**CLINCH RIVER
BREEDER REACTOR PROJECT
PRELIMINARY
SAFETY ANALYSIS
REPORT**

VOLUME 22

PROJECT MANAGEMENT CORPORATION

Figure Q321.12-1. Clinch River Navigation Chart

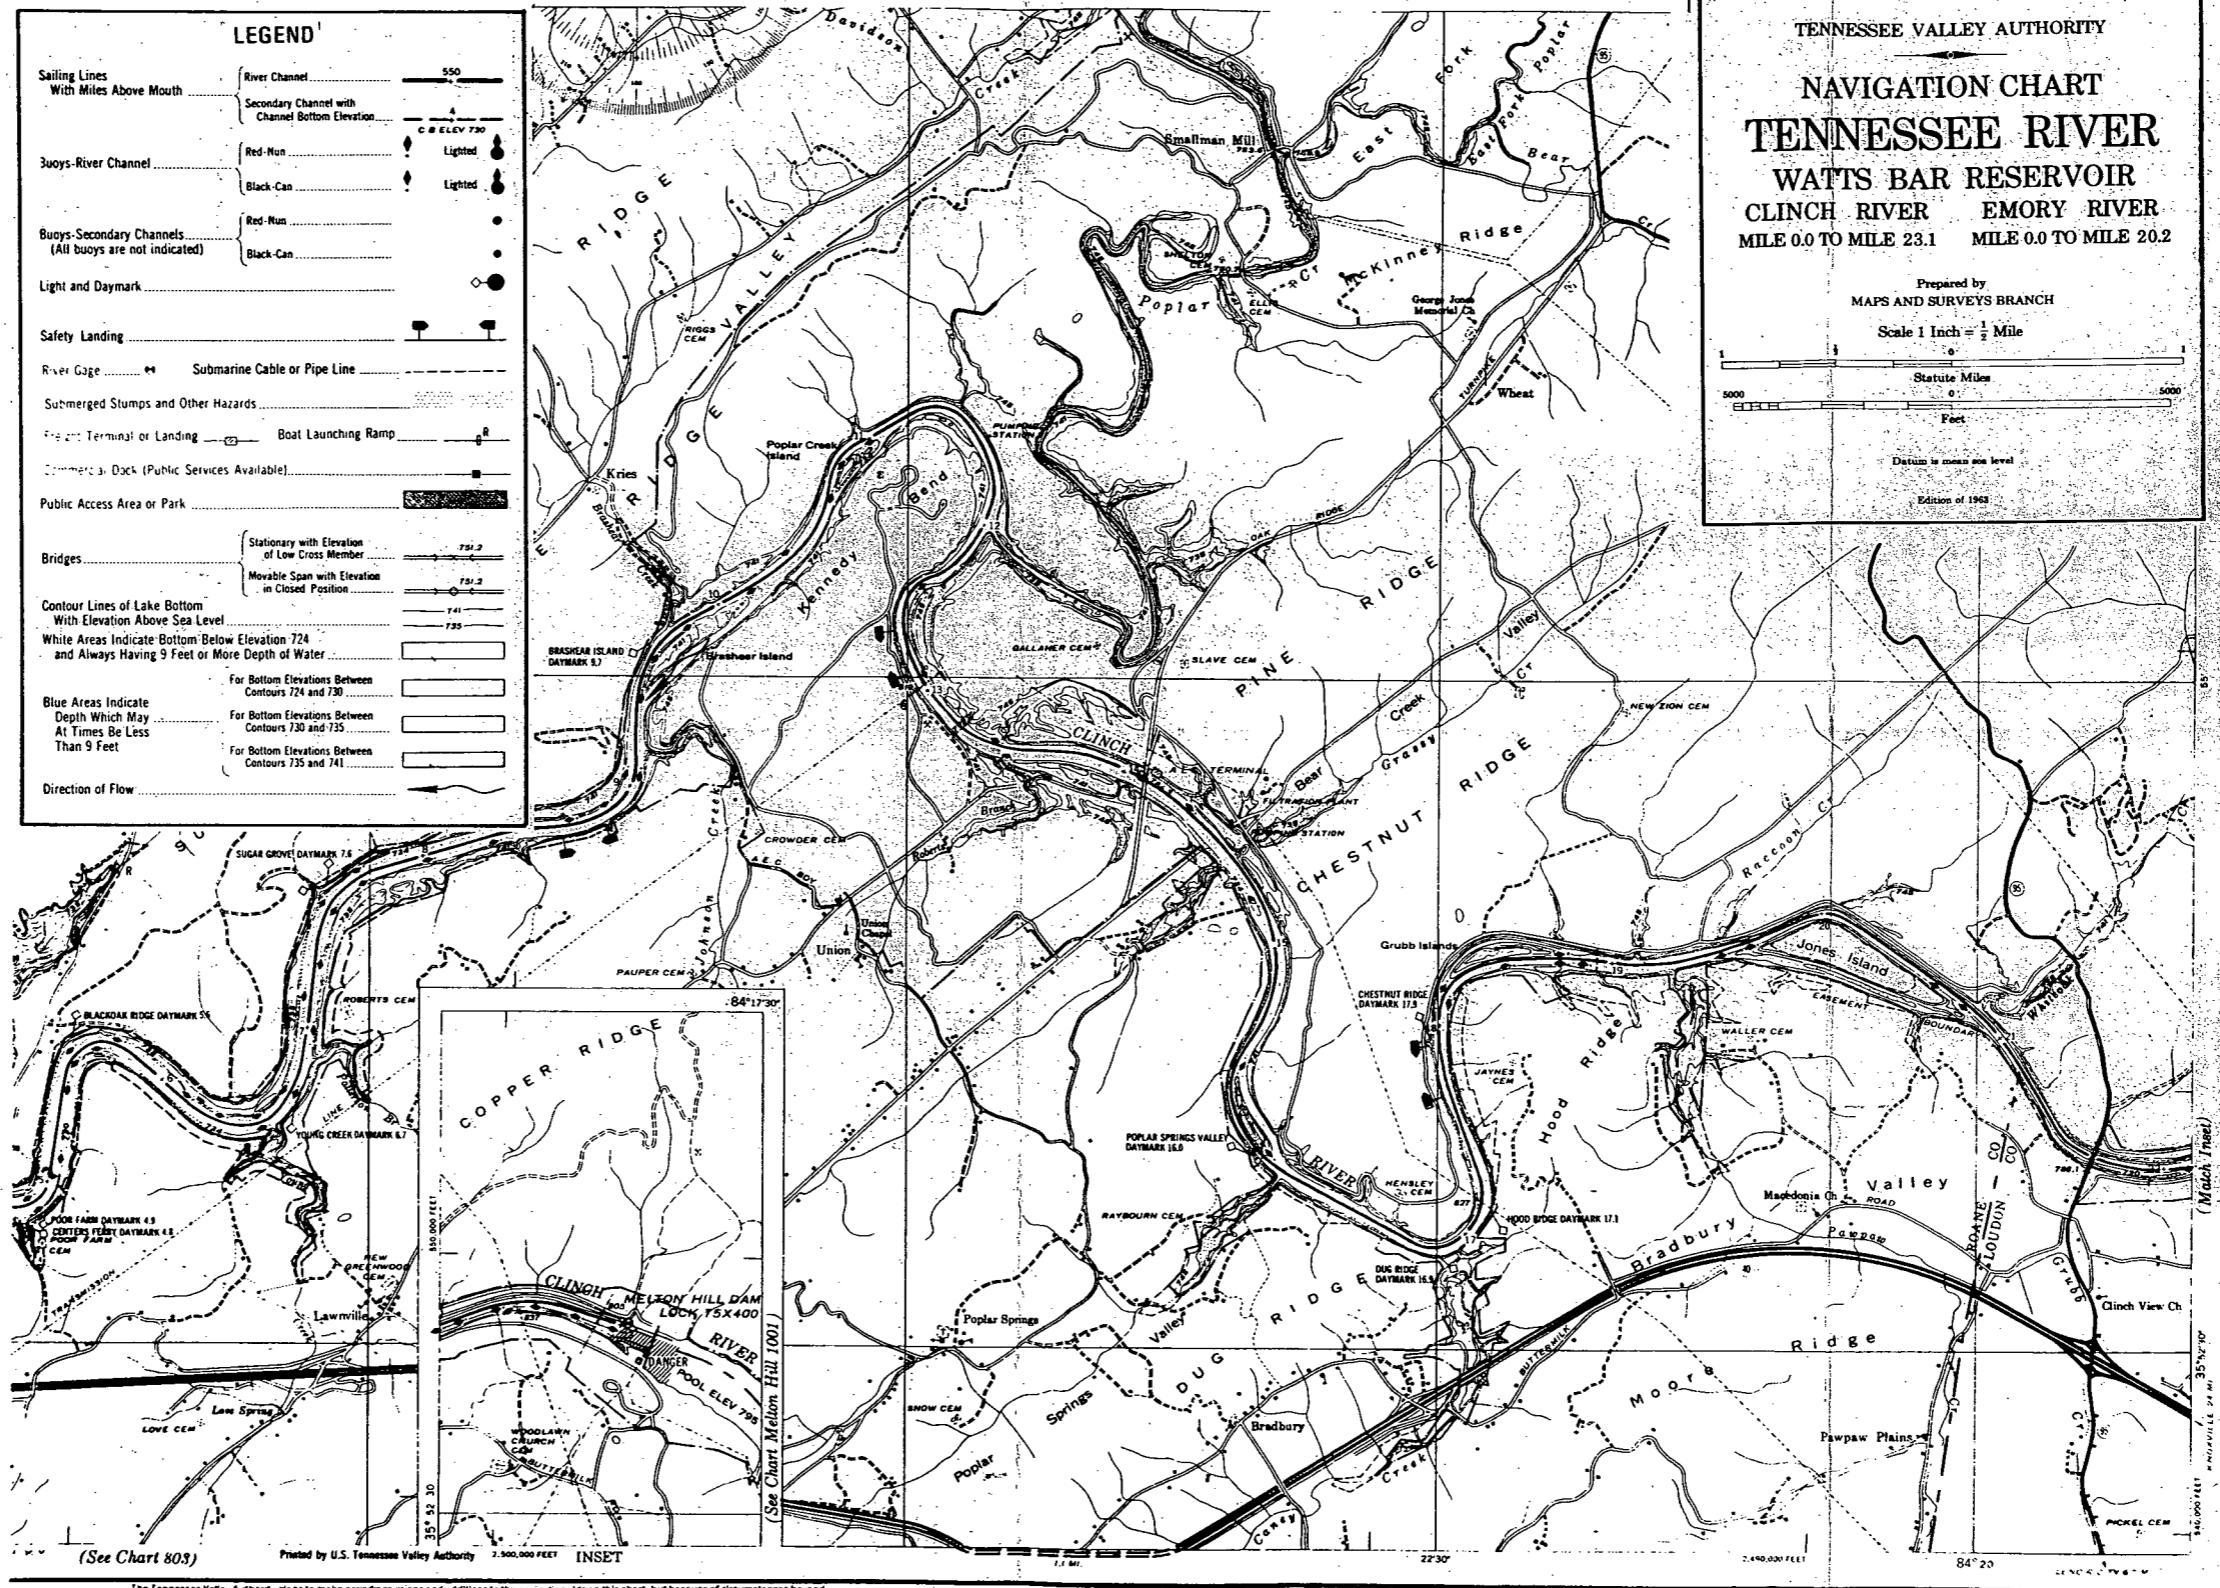
Provide a map showing lanes or other routes of river traffic near the site.

Figure Q321.12-1 contains a portion of TVA Tennessee River Navigation Chart #804 showing Clinch River Navigation Channel and navigational aids in the area of the site. Two large scale color copies of this chart will be separately forwarded to be used as a working set for regulatory review.

Figure Q322.8-1

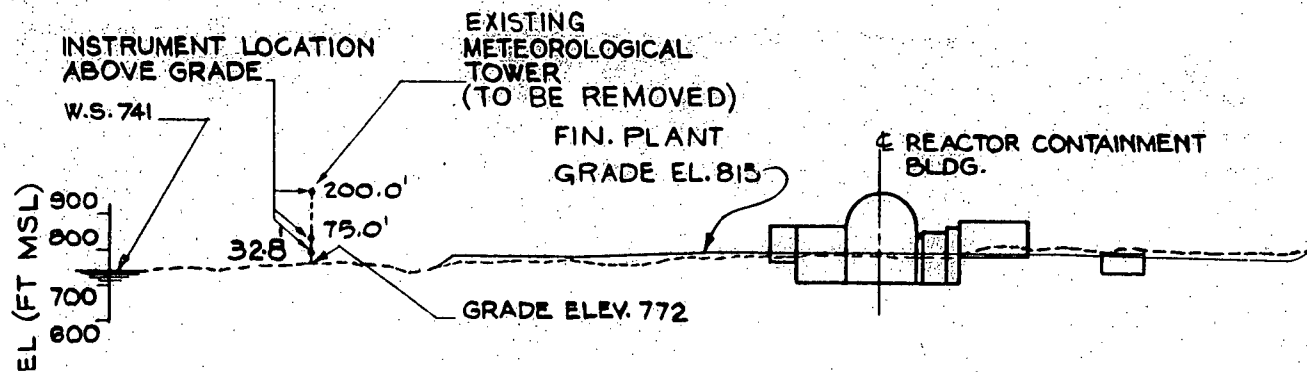
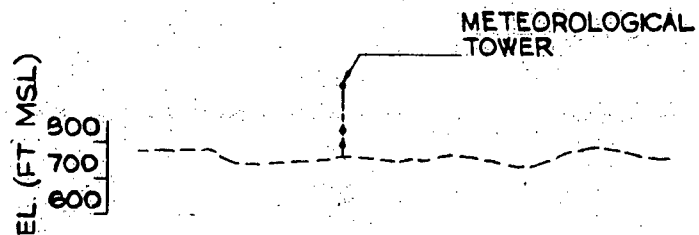
Provide topographic cross-sections indicating the relationship between the present tower and instrument locations and present and proposed grading of the plant site.

The information requested is provided in Figure Q322.8-1.

Figure Q322.9-1

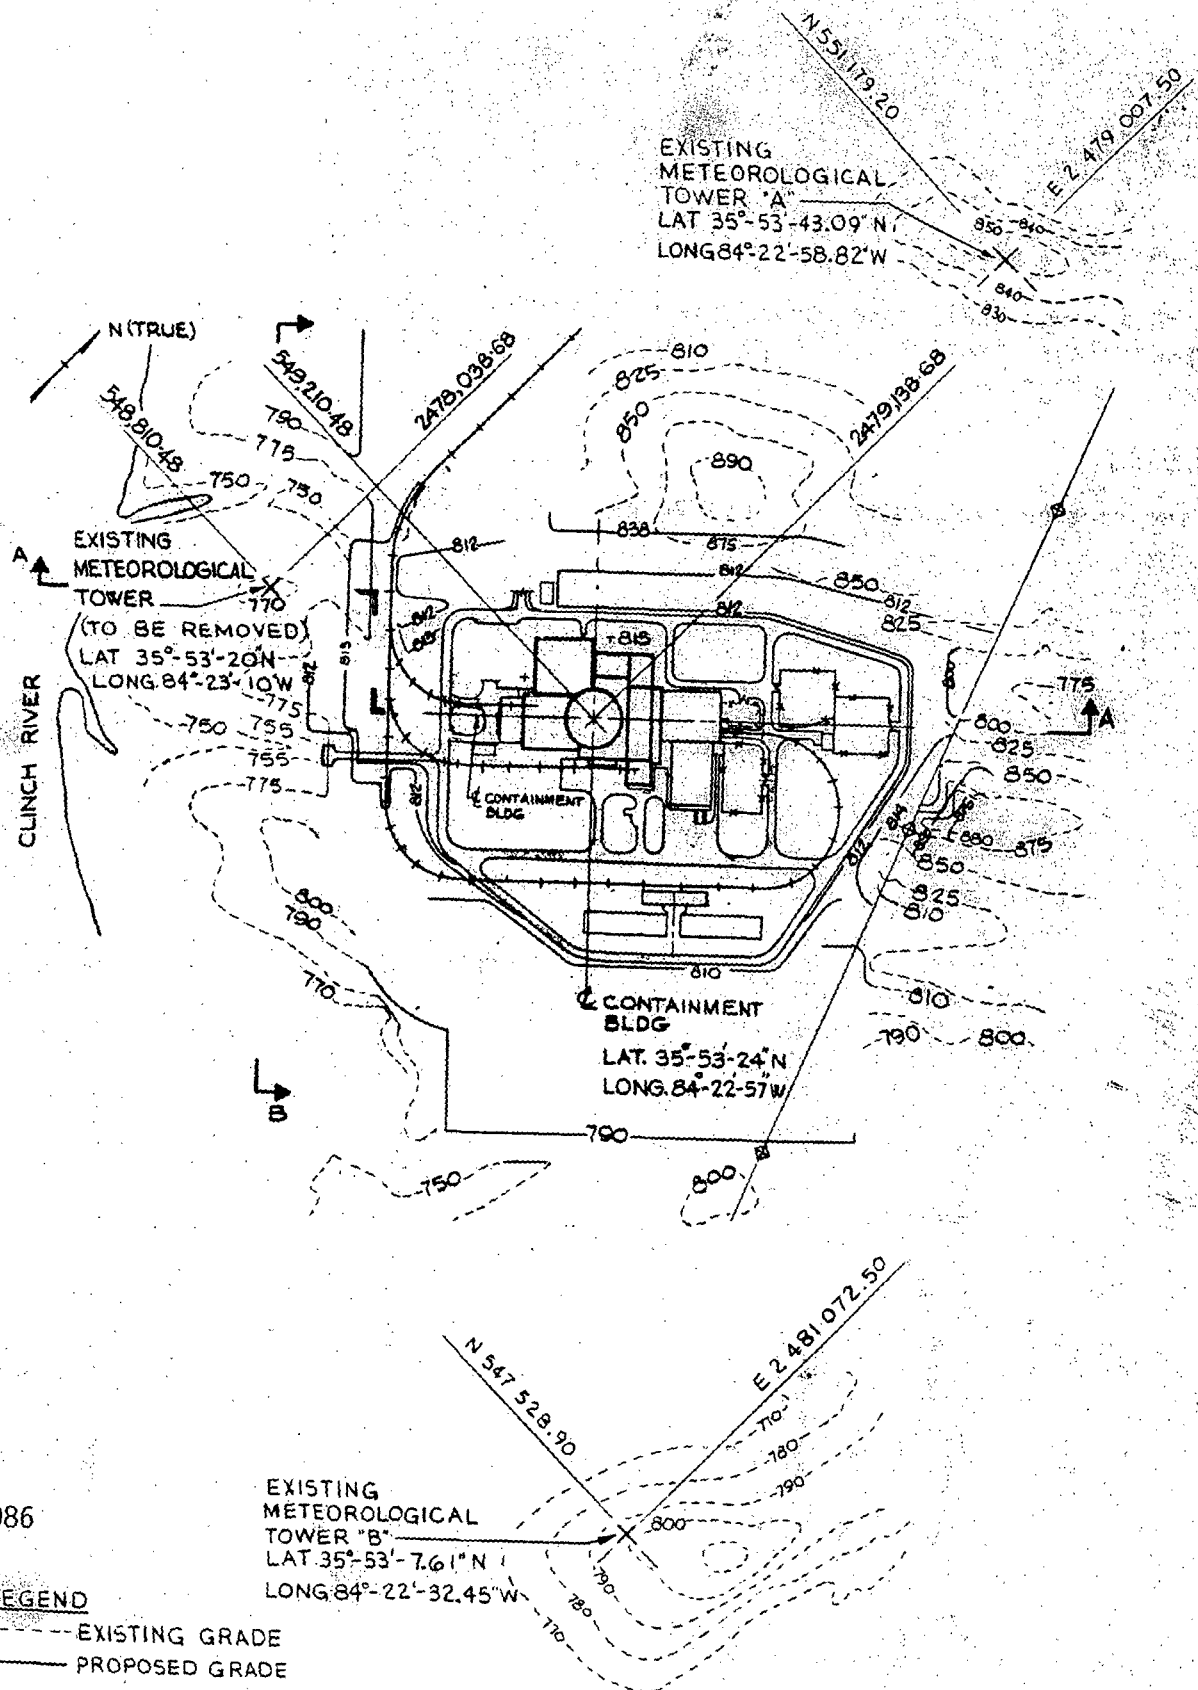
Provide a large scale topographic map indicating the location of the proposed plant structures with respect to the present and any other proposed meteorological towers.

The information requested is provided as Figure Q322.9-1.
